MFN 014-83
JNF 004-83

January 28, 1983

SUBJECT: IN THE MATTER OF 238 NUCLEAR ISLAND
GENERAL ELECTRIC STANDARD SAFETY ANALYSIS REPORT
(GESSAR II) DOCKET NO. STN 50-447

Attached please find the remaining final draft responses to the Instrumentation and Control Systems Branch (ICSB) questions in the Commission's October 5, 1982 request for additional information. These responses reflect the NRC/GE information exchange meetings held in Bethesda October 14 & 15, 1982; San Jose December 7-9, 1982; and again in Bethesda January 11-13, 1983.

Figure 1

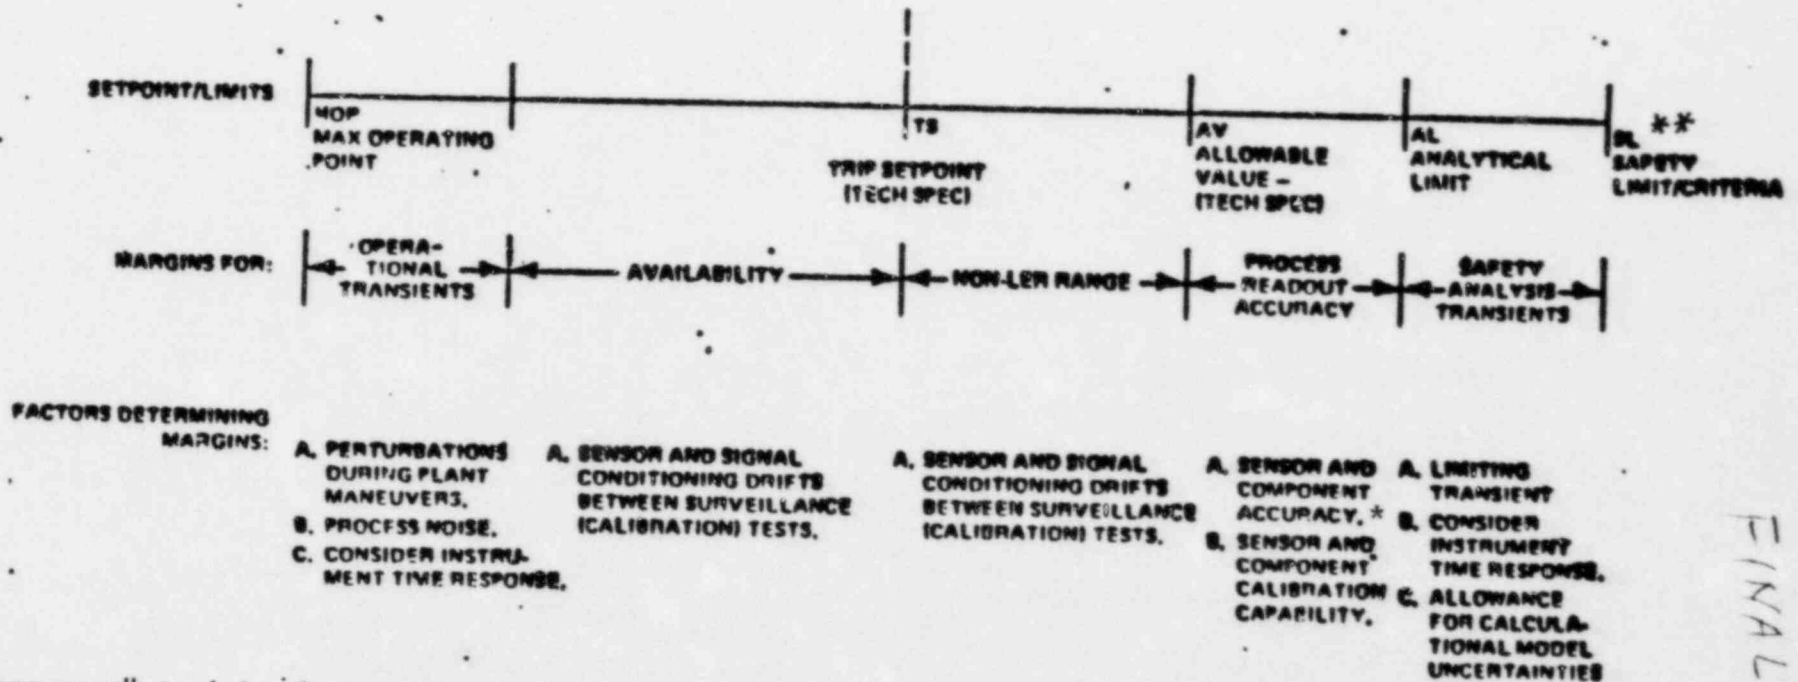
Provide a detailed discussion of your methodology to establish the trip setpoint and allowable value for each RPS and ESF channel, including the following additional information:

The method employed to establish adequate margins for instrument setpoint drift, inaccuracy and calibration uncertainty as discussed in NRC Regulatory Guide 1.105 is explained by reference to Figure 1. Because of the generic nature of this figure it is not drawn to any scale and is used solely to illustrate the qualitative relationships of the various margins. Starting with a Safety Limit as indicated at the extreme right hand of the figure, the first margin extends to the point marked Analytic Limit. This margin is there to account for uncertainties in the calculational model used but excludes allowances for instrumentation. Thus the calculational model can assume ideal or perfect instruments. The next margin is between the Analytical Limit and the Allowable Value of the parametric setpoint, and accounts for instrument errors and calibration capability for the specific instrumentation. The remaining margin which is of interest from a safety standpoint is that shown between the Allowable Value and the Instrument Setpoint. This margin is that which is deemed adequate to cover instrument drift which might occur during the established surveillance period. It follows that if during the surveillance period an instrument has drifted from its setpoint in a non-conservative direction but not beyond the allowable value, then the instrument performance is still within the requirements of the plant safety analysis. In this case, a Licensing Event Report (LER) would not be required.

For completeness Figure 1 shows further margin between the Instrument Setpoint and the Maximum (Licensed) Operating Point for the plant. During plant operation transient overshoots may occur for certain parameters and instrument "noise" may be present. The instrument setpoint may also drift in a conservative manner. There must be sufficient margin between the instrument setpoint and the maximum operating point to avoid spurious reactor scrams or unwarranted system initiations.

Not all parameters (functional units) have an associated analytical limit, and a Design Basis (DB) limit is indicated. In general, the analytic limit is employed in those cases where a functional unit setpoint is directly associated with an analyzed abnormal plant transient or accident as described in the FSAR, Section 15. Where a design basis limit is used it is not always possible to provide simple quantification of the limit, e.g., IRMs are only required to overlap in range with portions of the SRM and APRM ranges. A similar situation occurs with the main steam line radiation sensors which have a setpoint based essentially on previous operating experience.
